Illinois Tollway Base Sheet Revisions

Section M	Base Sheet Drawings		
	Drawing	Modification Summary	Effective: 03-1-2023
	Roadway (RDY)-Series 400		
	M-RDY-400	ROADWAY TYPICAL SECTIONS GROUP A	
		Revised high side superelevation slope label to "SE or Varies" on the mainline median side.	
		Added chemically stabilized subgrade to all sections.	
	M-RDY-401	ROADWAY TYPICAL SECTIONS GROUP B	
		Added chemically stabilized subgrade to all sections.	
	M-RDY-404	ROADWAY TYPICAL SECTIONS GROUP E	
		Revised Note 3 to include "(see the Sideslopes Hierarchy Table)".	
	M-RDY-406	ROADWAY TYPICAL SECTIONS GROUP G	
		Revised title of details, added paved shoulder in details.	
		Updated Note to Designer	
	M-RDY-407	GUARDRAIL SCHEDULE

APPROACH SLAB, MAINLINE

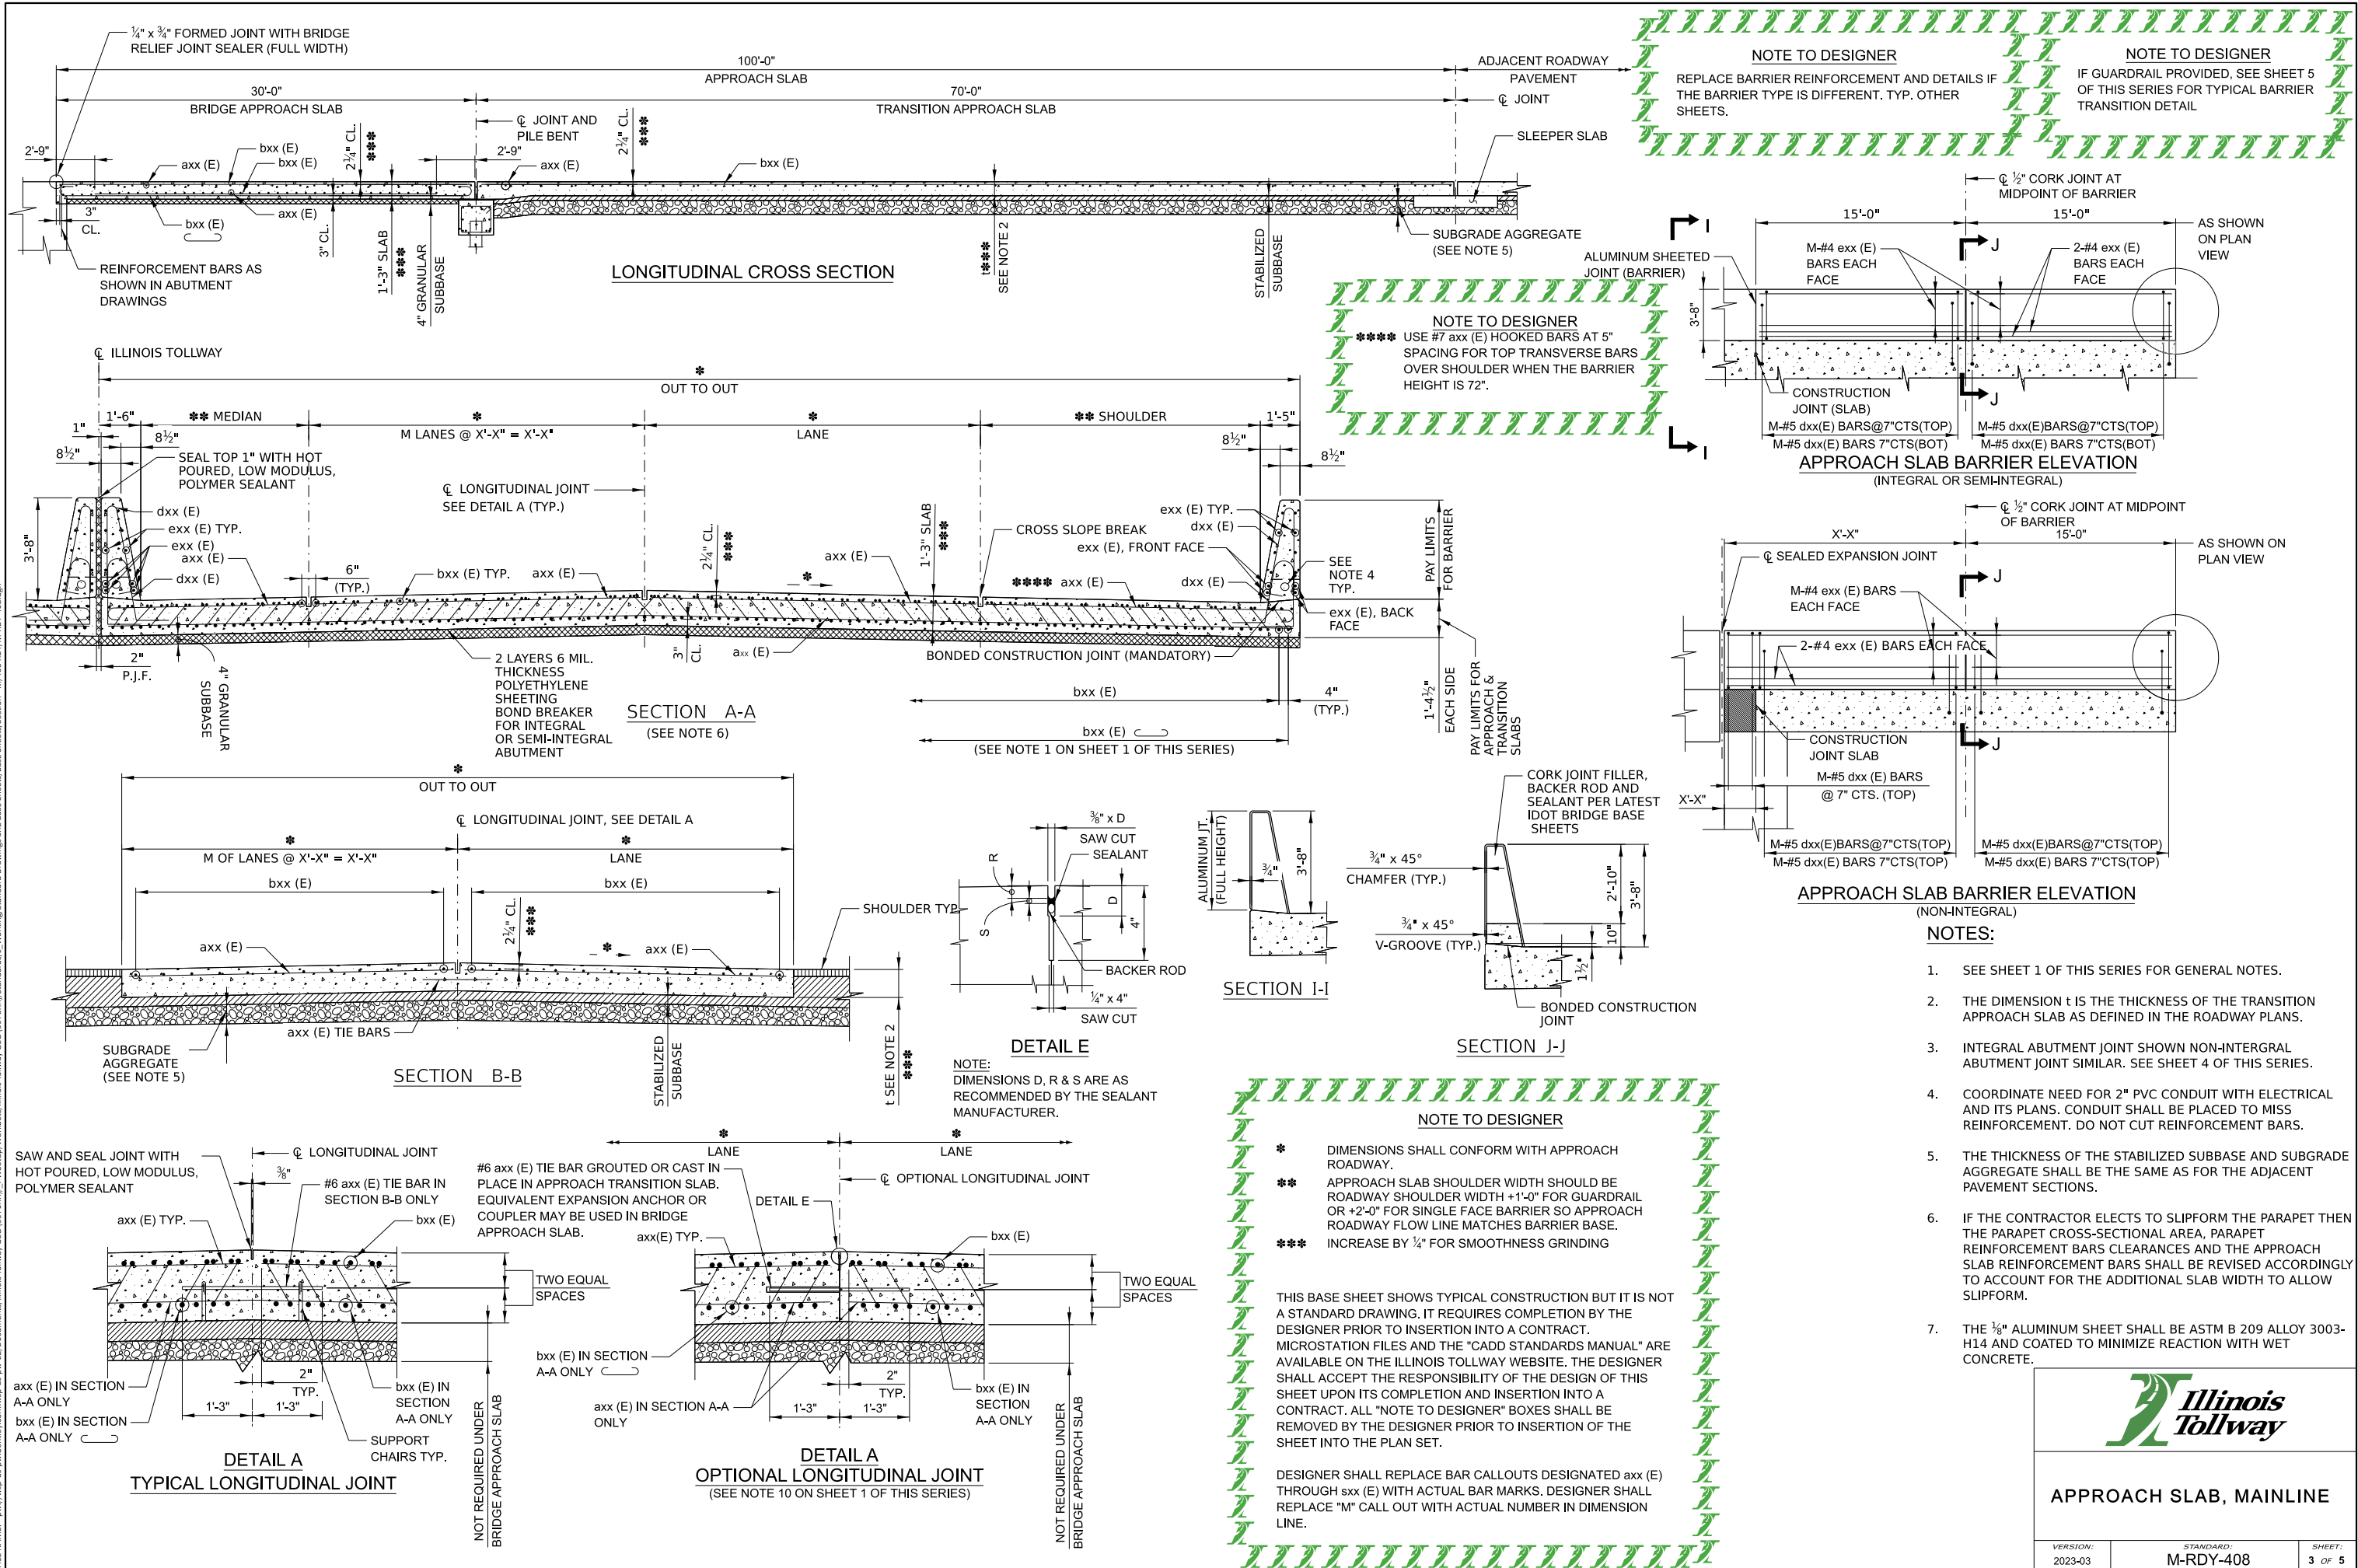
Sheet 5	Revised note callout in Typical Barrier Transition Detail where approach guardrail conflicts with the approach bent.	
		Changed Bonded Preformed Joint Seal from 2in to 3in.	
		Revised units for Bridge Deck Grooving and Bridge Deck Grooving (Longitudinal) to Sq. Yd.	
	M-RDY-409	APPROACH SLAB, RAMP

SECTION A-A
PRECAST BRIDGE APPROACH SLAB

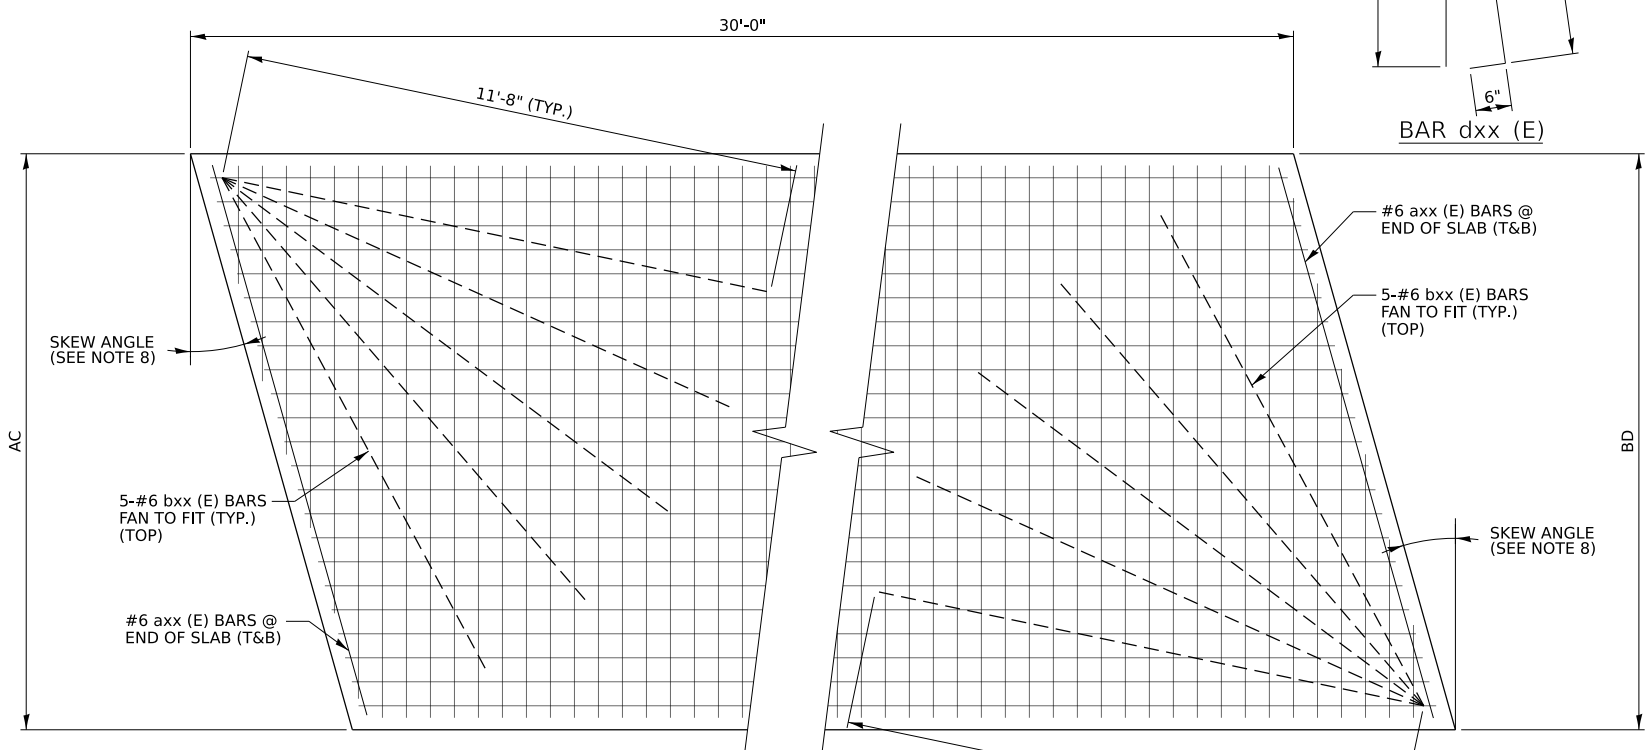
Sheet 3	Show straight bxx(E) bar 2'-9" from edges in Longitudinal Cross Section.	
		Add bar sizes and lengths to Precast Approach Slab Bar List.	
	Sheet 4	Revised units for Bridge Deck Grooving and Bridge Deck Grooving (Longitudinal) to Sq. Yd and pay item number for Precast Concrete Bridge Approach Slabs.

SECTION M-M
CIP TRANSITION APPROACH SHOULDER SLAB

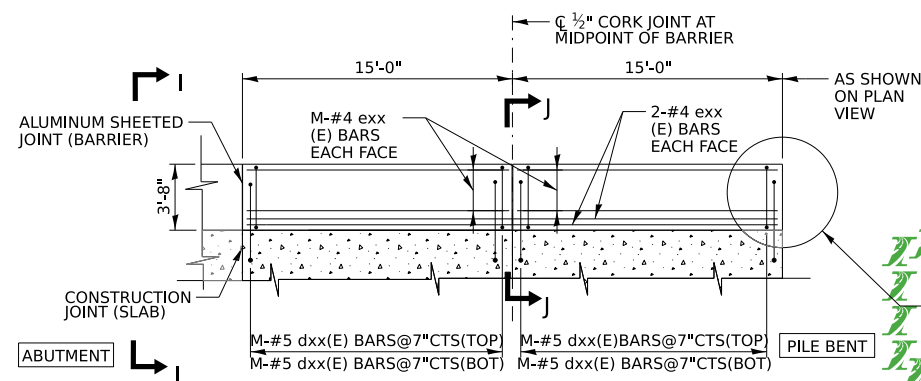
Sheet 5	Revised note callouts in Section M-M from 3 to 4.	
	Sheet 6	Add details showing rebar for the joint header.

TYPICAL CIP BARRIER TRANSITION DETAIL
(CURB AND GUTTER NOT SHOWN FOR CLARITY)

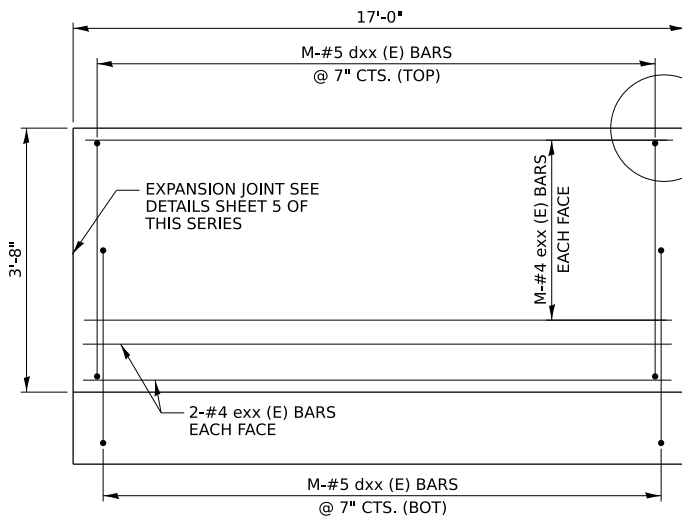
Section M	Base Sheet Drawings		
	Drawing	Modification Summary	Effective: 03-1-2023
	Roadway (RDY)-Series 400		
	Sheet 7	Changed exx(E) bars in Typical CIP Barrier Transition Detail to #4 bars	
		Add bar bend diagram for gxx(E) bar.	
		Remove ** from bar dxx(E) dimensions.	
		Changed Bonded Preformed Joint Seal from 2in to 3in.	
		Add straight bxx(E) bar to bill of material for CIP Transition Approach Should and CIP Transition Approach Slab.	
		Revised units for Bridge Deck Grooving and Bridge Deck Grooving (Longitudinal) to Sq. Yd.	
	M-RDY-412	ROADWAY SUBGRADE SLOPES MEDIAN BARRIERS	
		Revised Max. Rollover callout to be consistent with the same callout on the Base Sheet M-RDY-400.	
	M-RDY-413	DIAMOND GRINDING OF PLAZA	
		Revised monotubes and loops to be centered on the 100' CRC pavement area.	
		Renamed "PCC Transition Slab (Jointed)" to "Pavement Transition"	
	M-RDY-417	MAINLINE TOLL PLAZA PAVEMENT AND PAVEMENT MARKING DETAILS
